# Work Order ID 65520

Item Name: 205 Skidtube bent detail

DRAWING NO. D2580	TITLE 205 SKIDTUBE ASSEMBLY	REV. D	DART AEROSPACE LTD ENGINEERING ORDER		D.E.O. NO. D2580-D-1	SHEET NO. SHEET 1 OF 1	SCALE NTS
DRAWN <i>UP</i>	CHECKED <i>L</i>	MFG. APPR. <i>E</i>	APPROVED <i>MP</i>		DE APPR. <i>H</i>		
DATE 10.09.22	DATE 10.11.04	DATE 10.11.04	DATE 10/11/04		DATE 10.11.04

CHANGE ALL WELDED CROSSBOLT SPACERS TO SWAGED SPACERS

SECTION D-D & SECTION H-H ARE AMENDED AS FOLLOWS:

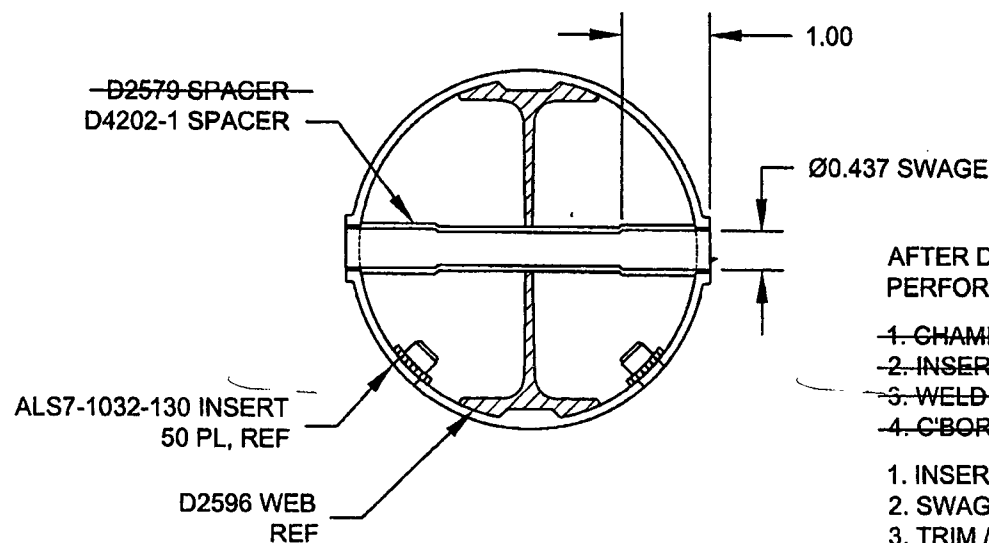
PARTS LIST IS AMENDED AS FOLLOWS:

WAS

QTY	QTY	PART NUMBER	DESCRIPTION
-041	-045		
20	24	D2579	CROSS BOLT SPACER

1. CHAMFER HOLE 0.050 X 45°
2. INSERT D2579 SPACER (20 PLACES)
3. WELD INTO PLACE AND GRIND FLUSH
4. C-BORE D2579 SPACER TO Ø0.437 X 1.00 DEEP

IS

20	24	D4202-1	SPACER
----	----	---------	--------

AFTER DRILLING AND BENDING ASSEMBLY  
PERFORM THE FOLLOWING FOR Ø0.508 HOLES ONLY:

1. INSERT D4202-1 SPACER, 20 PL (-041) OR 24 PL (-045)
2. SWAGE TO Ø0.437 X 1.00 DEEP PER QSI 002
3. TRIM / GRIND FLUSH PER QSI 002
